STAFF RECOMMENDATION

1008 B Villa Place

April 22, 2020

Application: New Construction—Outbuilding; Setback Determination

① SITE PLAN
1" = 10'-0"

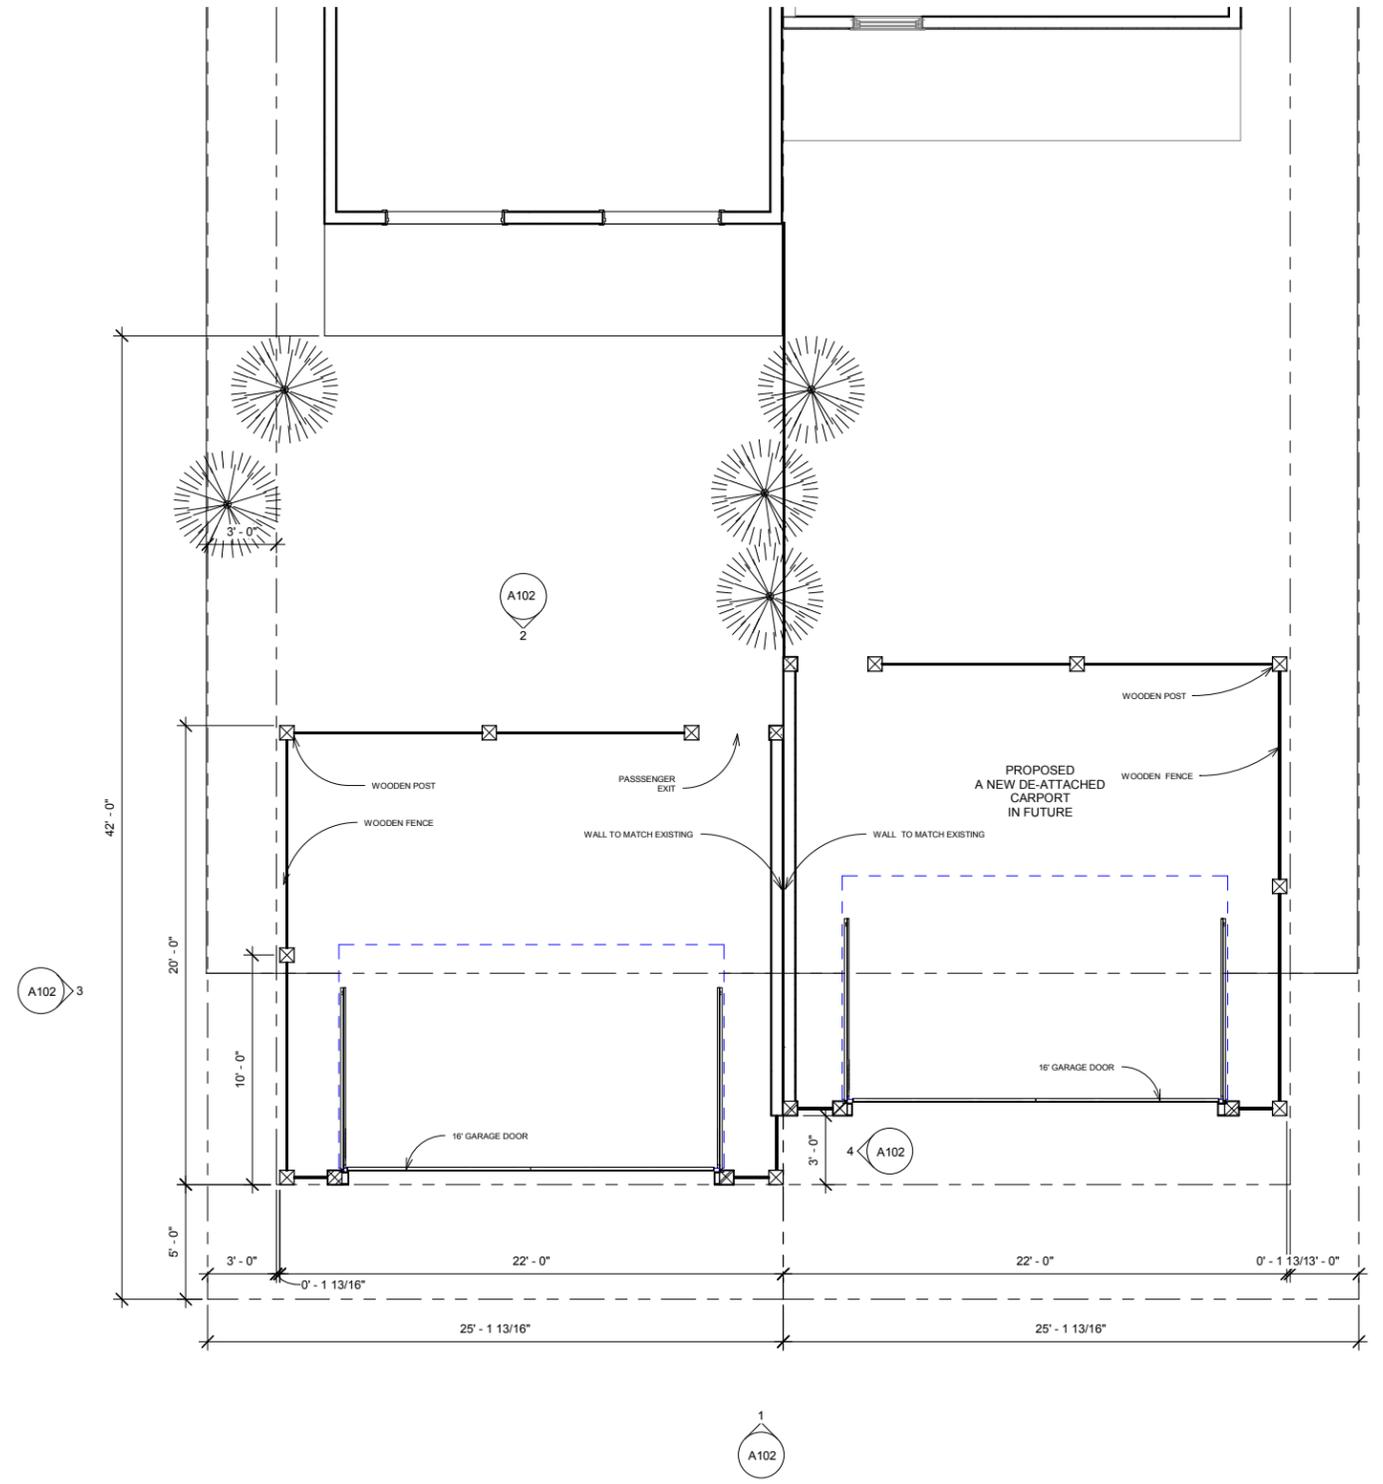
Setback & Rhythm of Spacing: The outbuilding will be located behind the principal building, with a rear setback of five feet (5') from the rear property line. This is an appropriate rear setback for outbuildings with garage doors facing an alley.

The side setbacks are proposed to be three feet (3'). The required minimum side setback for an outbuilding of this size, under both the design guidelines and the bulk zoning regulations, is five feet (5'). Staff recommends increasing the side setback to five feet (5') or reducing the square footage of the outbuilding (both halves together) to seven hundred square feet (700 sq. ft.) or less.

The two halves of the outbuilding will be offset, as are the two halves of the principal building. With this configuration, the separation between the principal building and the half of the outbuilding currently proposed will be seventeen feet (17'); the latter half will be twenty-three feet (23'). Staff finds that the average separation is consistent with the design guidelines, which generally require twenty feet (20') between primary and accessory structures on a lot.

1. The total footprint of outbuildings shall not exceed seven hundred, fifty square feet (750 sq. ft.);
2. The side setback shall be no less than five feet (5'), unless the building is reduced to seven hundred square feet (700 sq. ft.) or less, in which case the setback may be three feet (3'); and,
3. All metal roof selection and color shall be administratively approved prior to construction.

With the condition that the outbuilding meets the required five foot (5') side setbacks, staff finds that the outbuilding would meet Sections III.C. and IV.E of the Edgehill design guidelines.

If the building is reduced to seven hundred square feet (700 sq. ft.) or less, the setback may be as little as three feet (3').

② PROPOSED DE-ATTACHED CARPORT
1/4" = 1'-0"

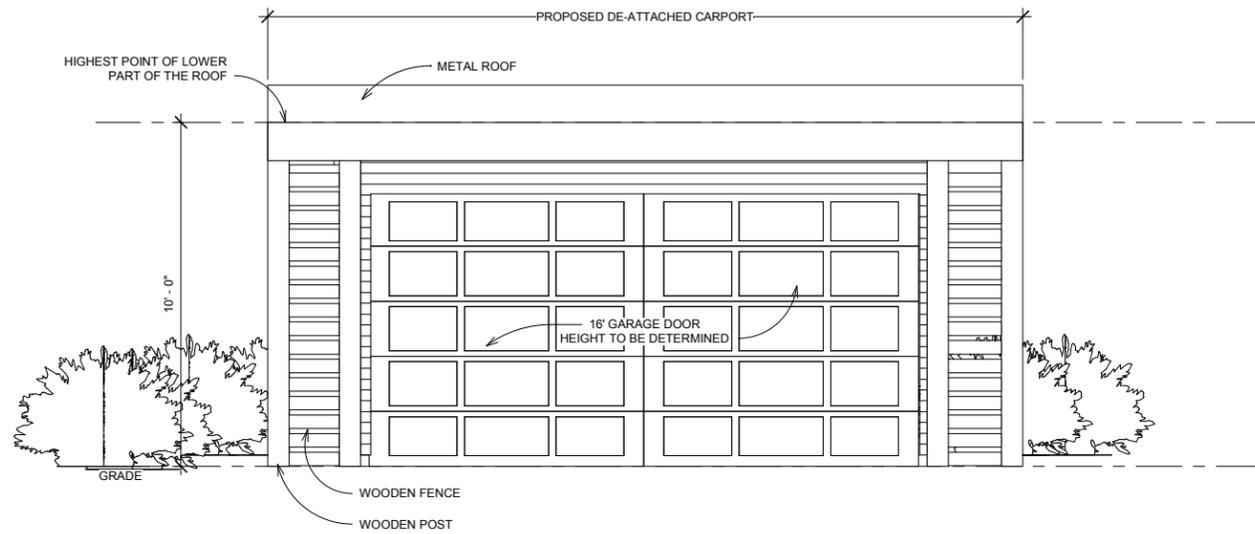
The current proposal is to build a four hundred, forty square foot (440 sq. ft) garage. This will serve Unit B, with a matching second half of the building to be built later to serve Unit A. Upon completion of the second half, the outbuilding will have a total footprint of eight hundred and eighty square feet (880 sq. ft.). The design guidelines allow outbuildings on lots this size to be seven hundred, fifty square feet (750 sq. ft.) in footprint.

With the condition that the footprint of both halves together will not exceed seven hundred, fifty square feet (750 sq. ft.), staff finds that the height and scale of the proposed outbuilding will meet Section IV.A. of the Edgehill design guidelines.

The applicant could meet this condition by limiting the size of the second half of the carport for Unit A to three hundred, ten square feet (310 sq. ft.), or reducing the size of both halves of the building to three hundred, seventy-five square feet (375 sq. ft.), or any other configuration where the total does not exceed seven hundred, fifty square feet (750 sq. ft.)

① EAST ELEVATION
3/8" = 1'-0"

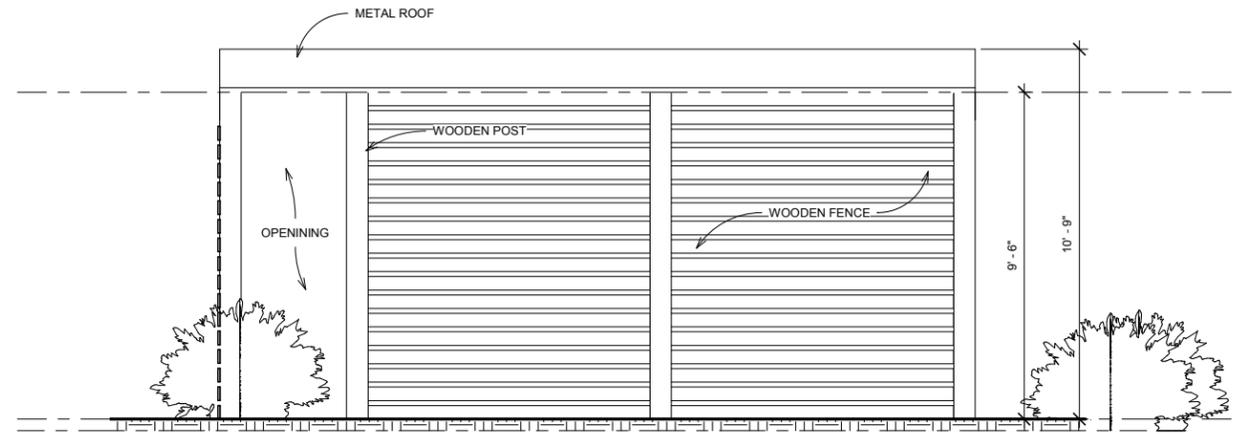
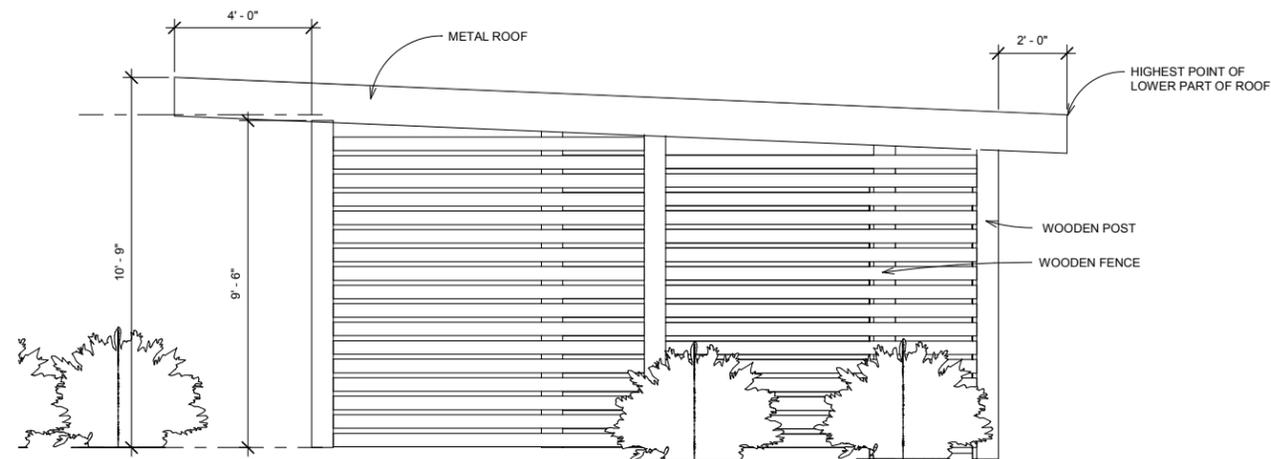
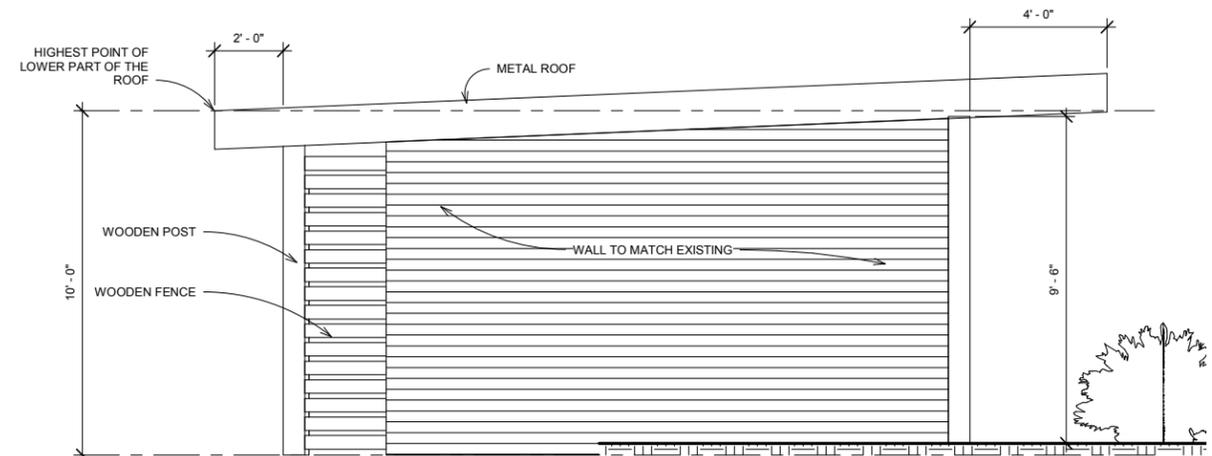
The outbuilding will have a low-sloped roof with a bottom eave height of nine feet three inches (9'-3"), and a maximum height of ten feet, nine inches (10'-9").

Roof form: The roof of the outbuilding will be a low-sloped shed roof. This roof is not typical of outbuildings historically, but it is compatible with the contemporary form of the principal building.

Staff recommends that, as a condition of approval, that the roofing selection and color is approved prior to construction.
